7-ELEVEN STORE #42975 SITE #1057022
MAJOR SITE DEVELOPMENT PLAN

MAJOR SITE DEVELOPMENT PLAN
7-ELEVEN - STORE #42975
SITE #1057022
BRADLEY ROAD AND LEGACY DRIVE
COVER SHEET

MAJOR SITE DEVELOPMENT PLAN  
7-ELEVEN - STORE #42975  
SITE #1057022  
BRADLEY ROAD AND LEGACY DRIVE  
SITE PLAN

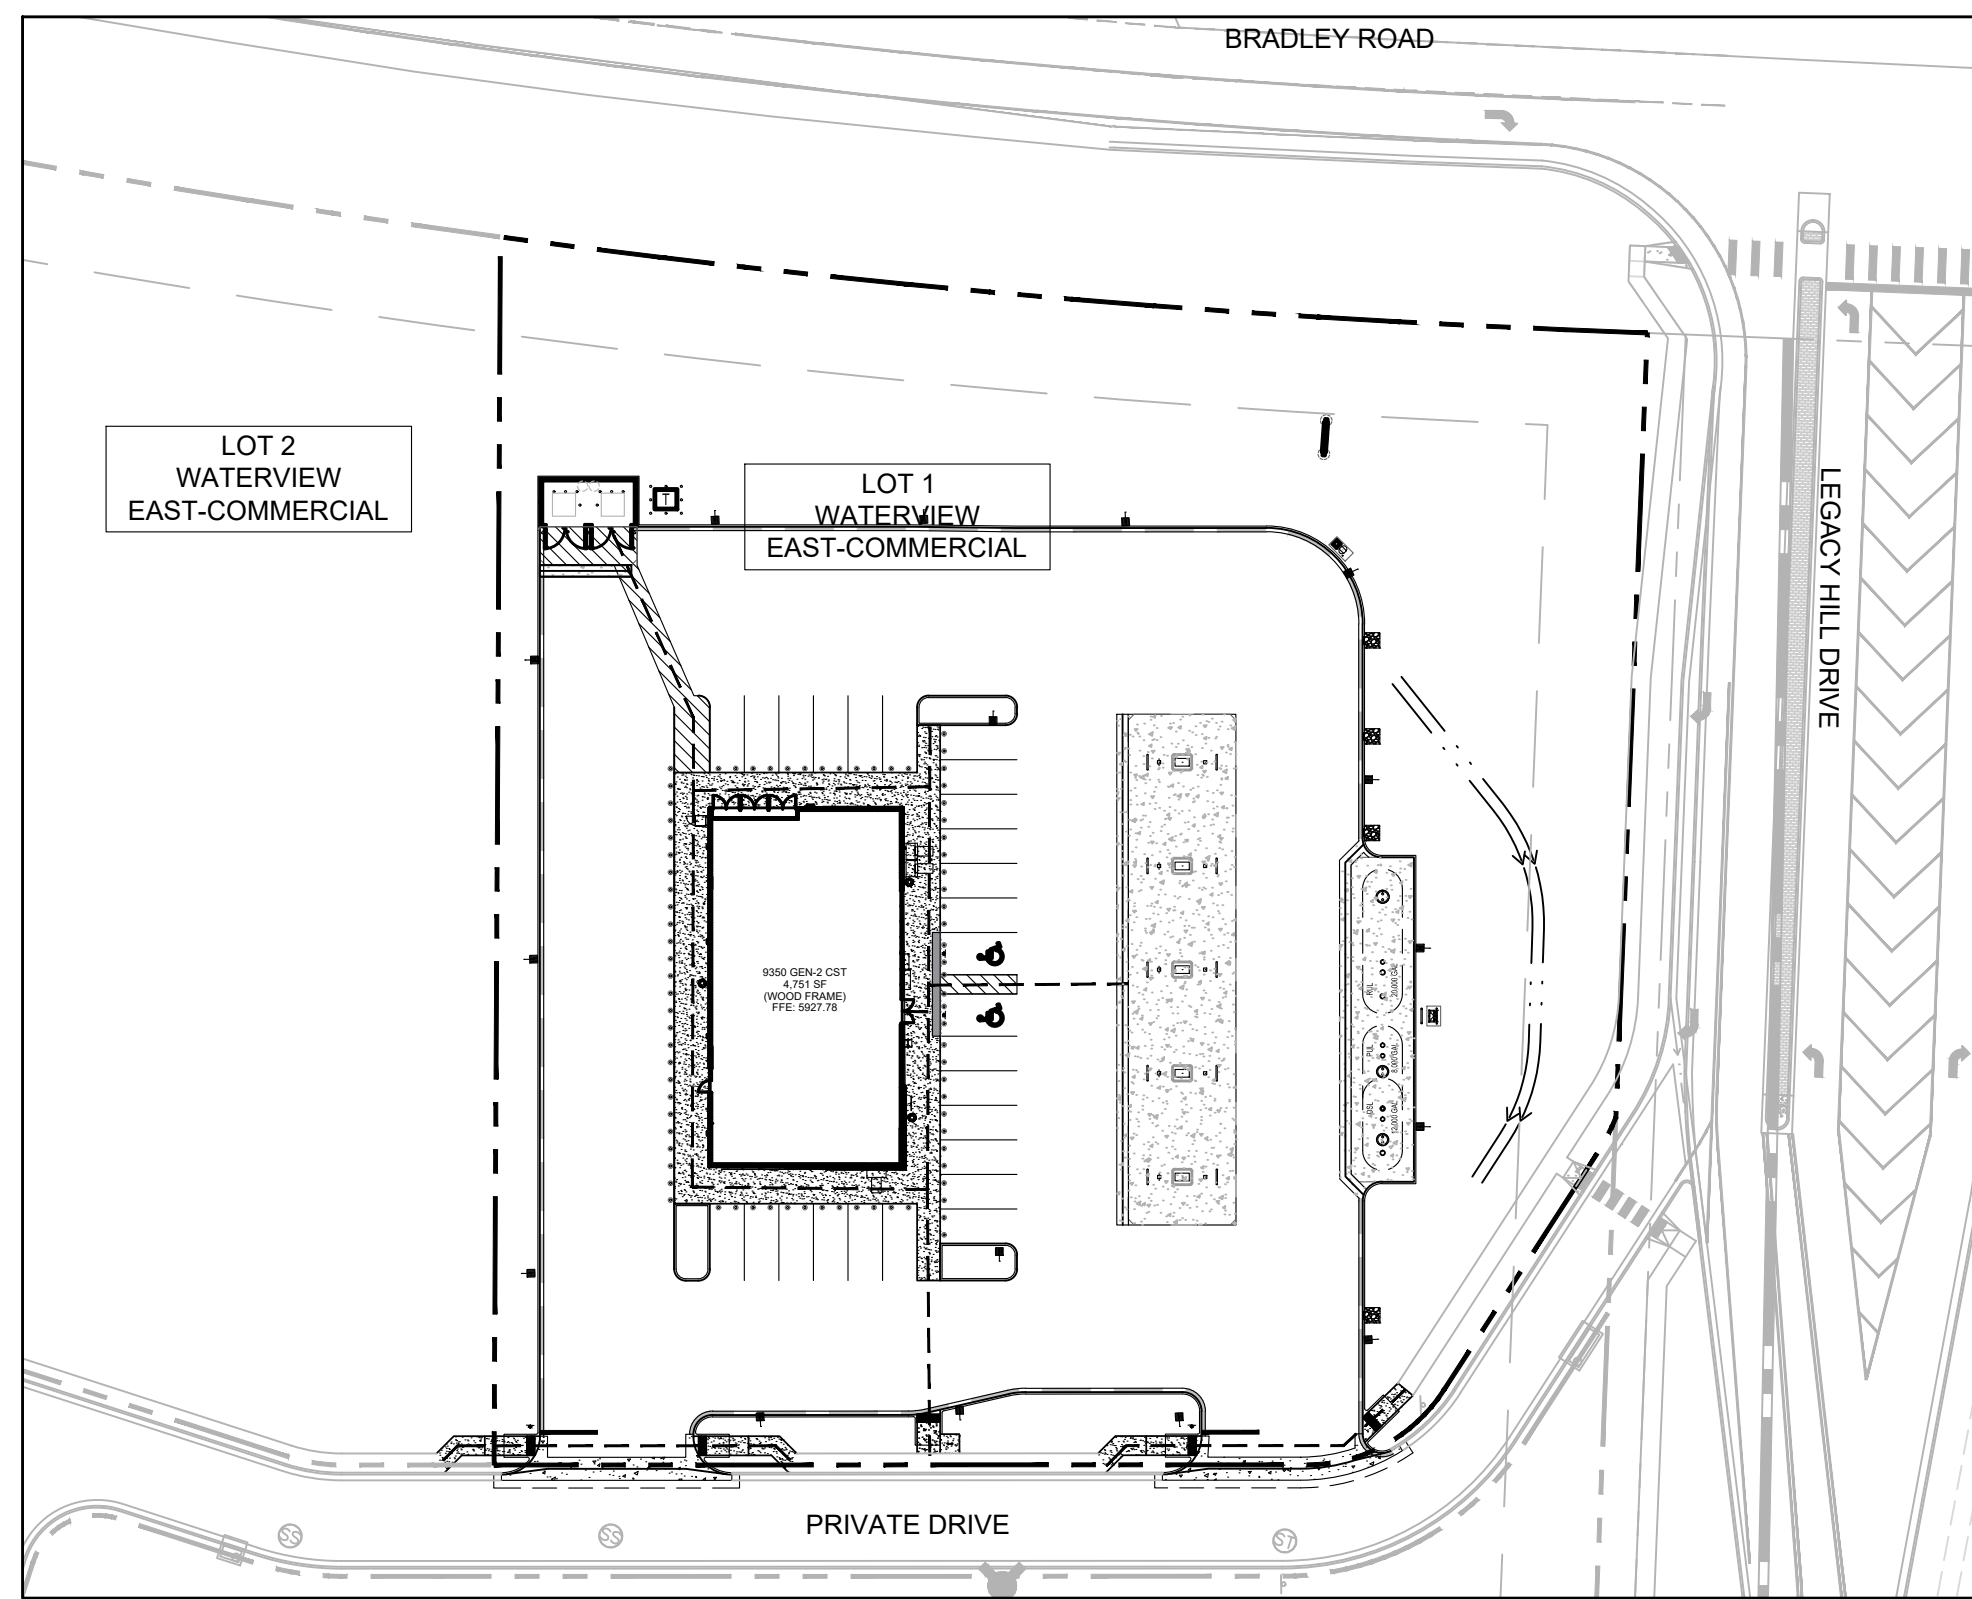
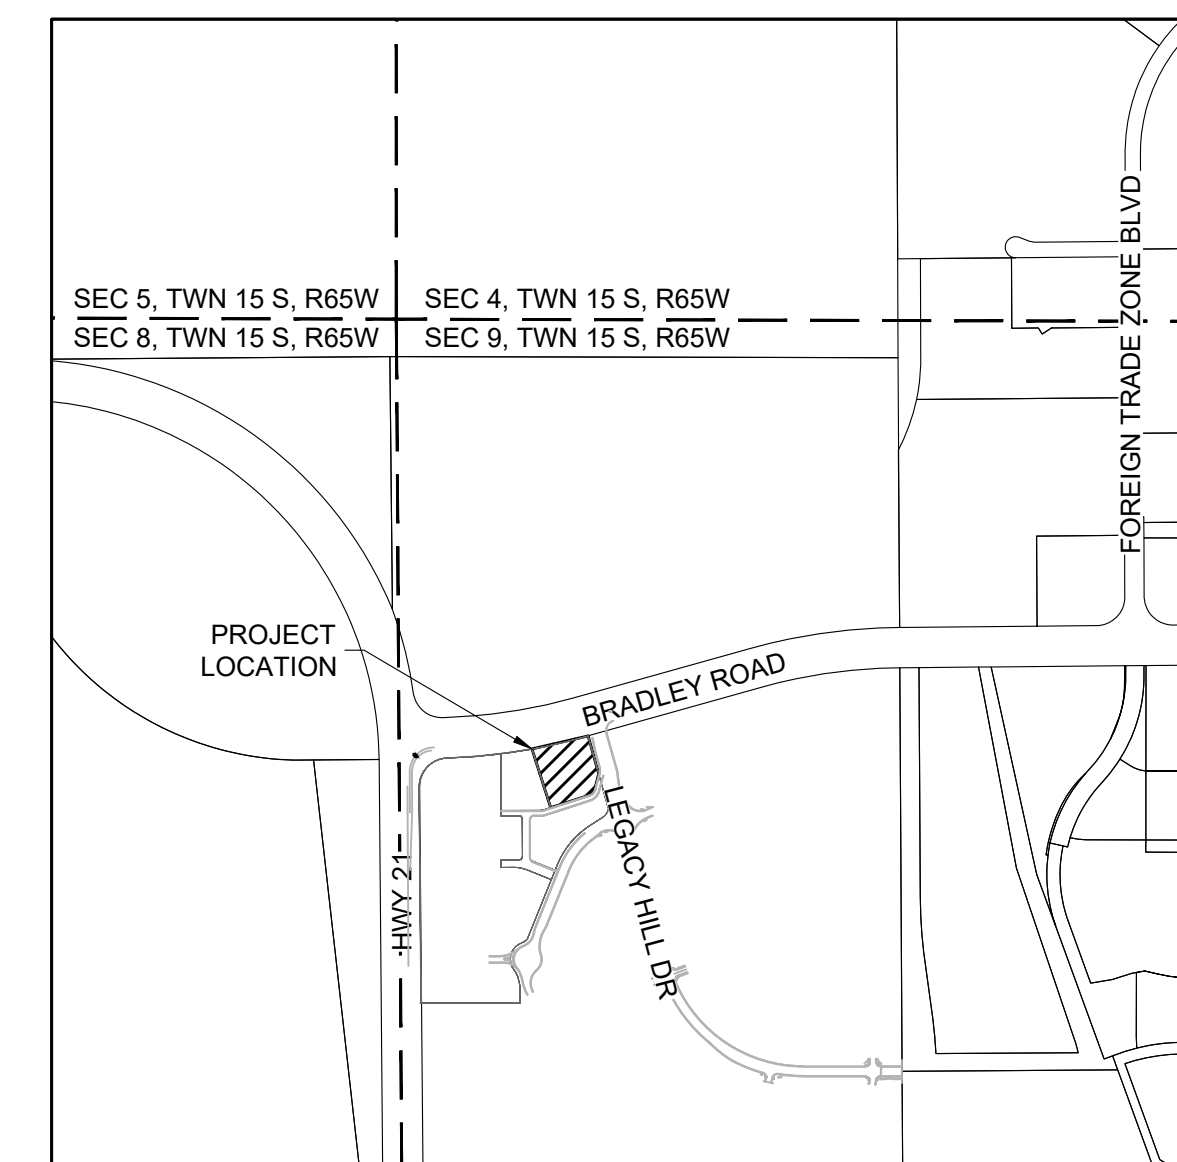
Please provide only the Site plan and relevant notes for this "Site Development Plan" document. All other documents which have been or need to be submitted separately as part of this overall submittal should be removed from this specific document.
